# MEMORANDUM

DATE: May 6, 2008  
TO: Jim Stanton, Golden Valley Watermaster  
FROM: Cindy Yenter, WD140 Watermaster *CY*  
CC: Tim Luke, IDWR  
RE: Cottonwood Creek Recharge

North Recharge Site weir – modification diagram

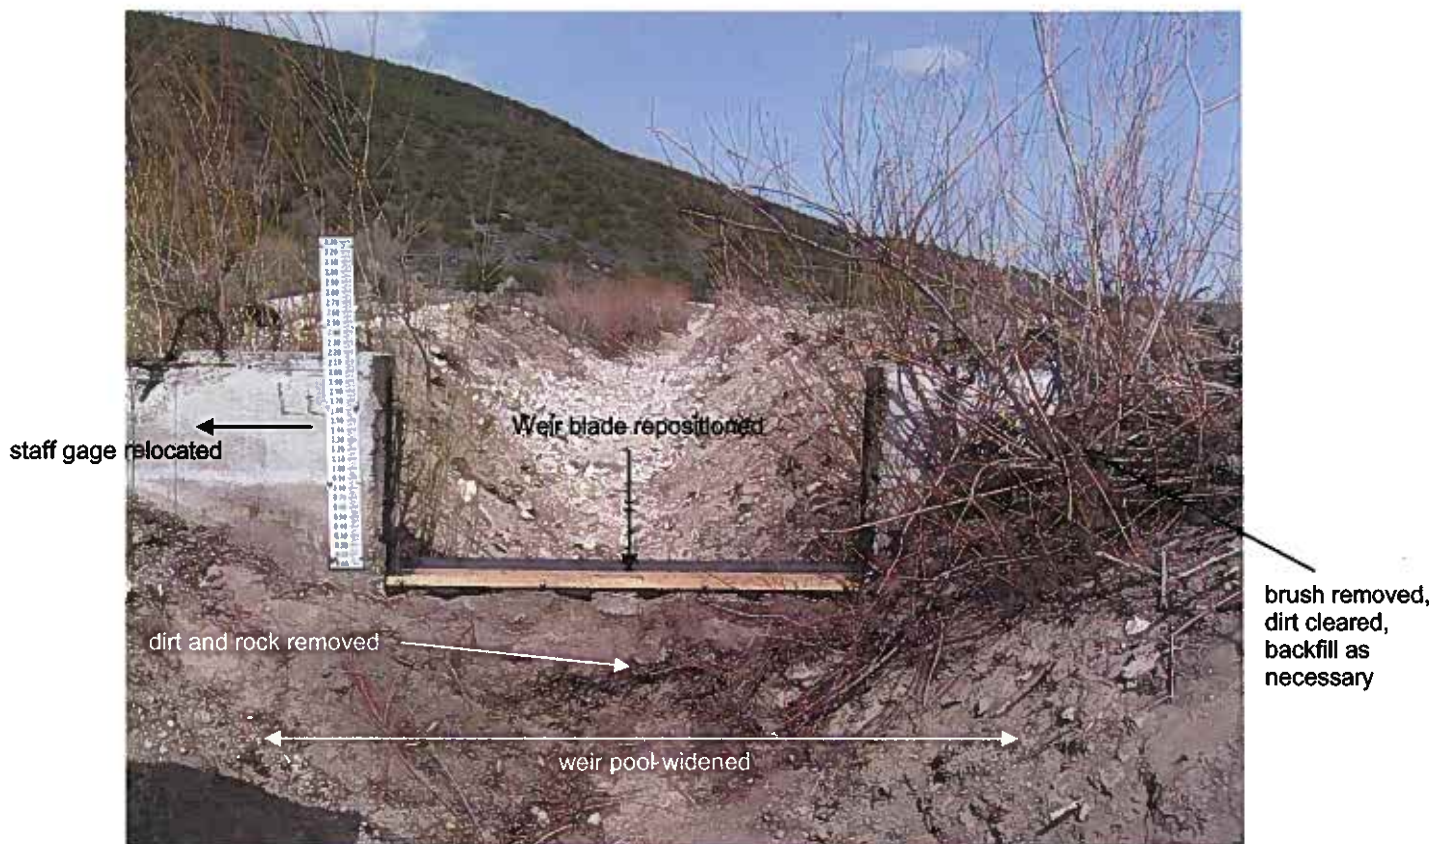
This is a decent measurement location with an existing concrete bulkhead in the ditch just above the recharge pond. There is plenty of downstream drop and sufficient channel armoring for the operation of a sharp crested weir. The new 5-foot weir blade and staff gage are not installed correctly, however, and there is significant maintenance required in the weir pool upstream from the weir. The following list details required modifications and maintenance to the weir and measurement site:

- The weir blade must be installed on the upstream side of the 2X4 sill plate, to be made flush with the upstream face of the concrete bulkhead and the steel channel iron on the upstream sides of the opening.
- The staff gage must be moved away from the weir opening, a minimum distance of two times the maximum anticipated head over the weir. If this will not be possible, the staff gage may be mounted on or in the stilling well. Zero on the staff gage must be level with the top edge of the weir crest. I recommend use of an engineer's level to set the staff elevation.
- Dirt and rock must be cleared away from the upstream face of the concrete bulkhead below the weir blade, and away from the sides of the weir opening. The vegetation and willows

growing on the bank and next to the concrete structure must be removed and dirt backfill replaced around the structure as necessary.

- The weir entry pool should be widened slightly, upstream as far as the stilling well.
- The stilling well and recorder box need cleaned out.
